SUBJECT: Forwards addl info re steam generator repairs, in response to  
 NRC 810129 ltr. Drawing of steam generator leg assembly encl.

February 17, 1981  
L-81-40

Re: Turkey Point Units 3 and 4  
Docket Nos. 50-250 and 50-251  
Steam Generator Repairs

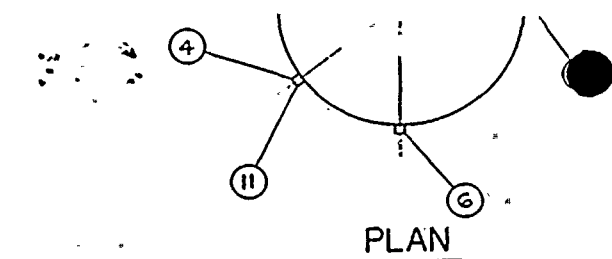
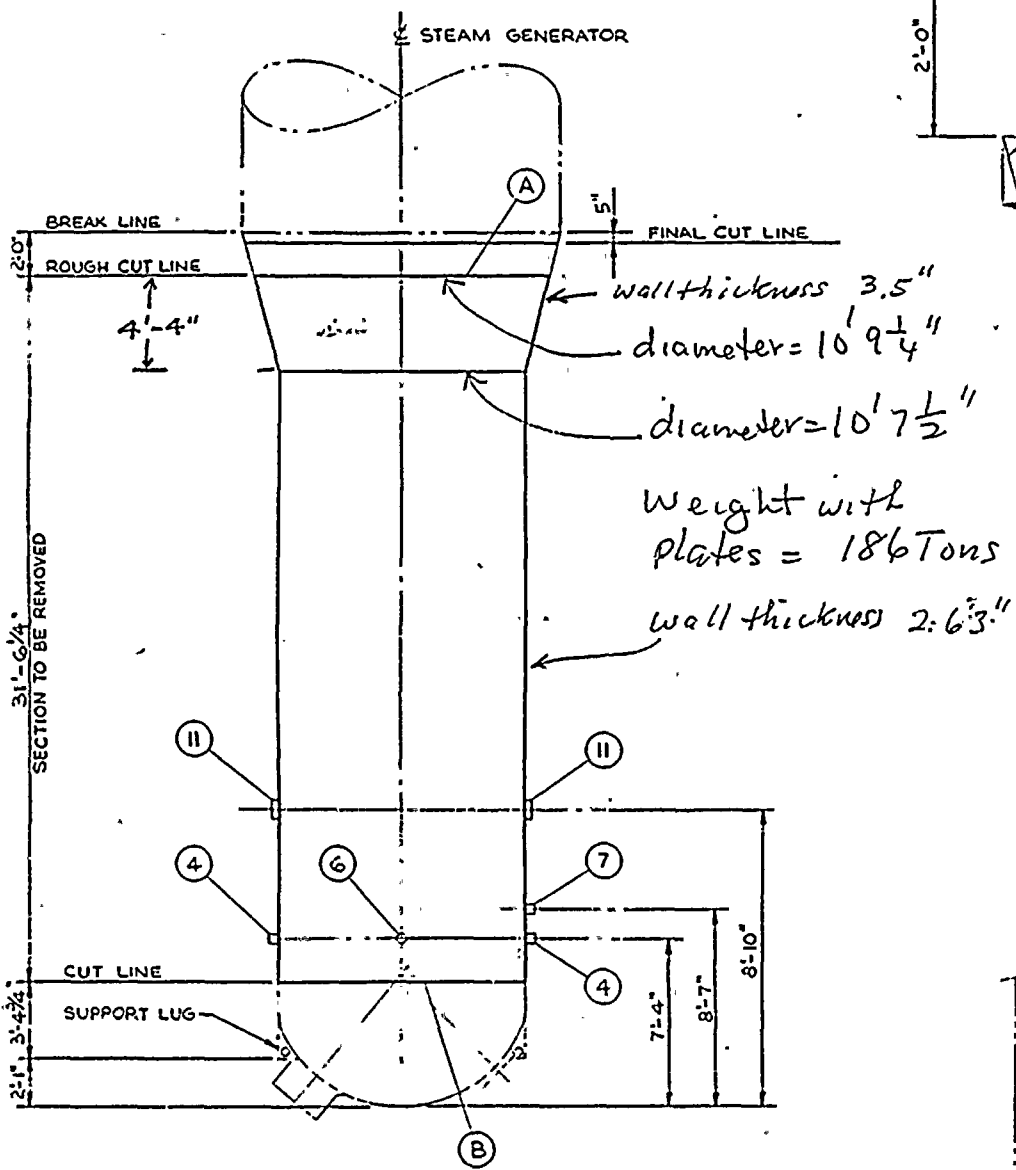
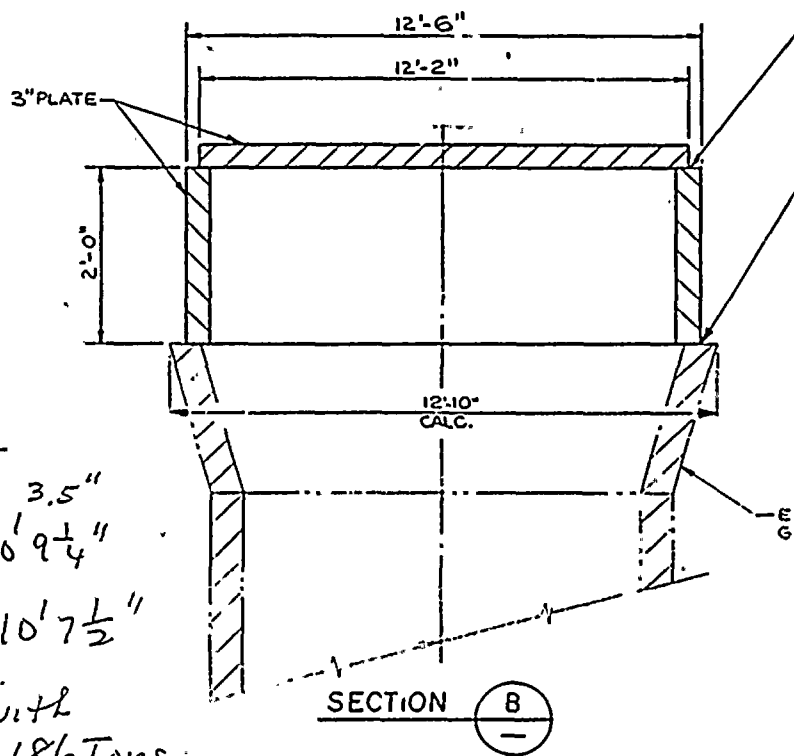
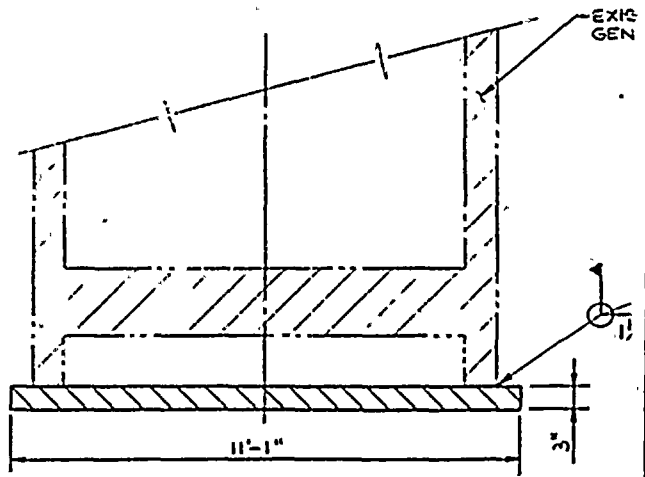
- (1) The drawing of the steam generator assembly SGRR figure 3.3-7 does not have dimensions of the steam generator assembly. Provide the dimensions necessary to calculate the volume of the assembly.

A drawing of the SGLA is attached with the necessary dimensions and the weight written in.
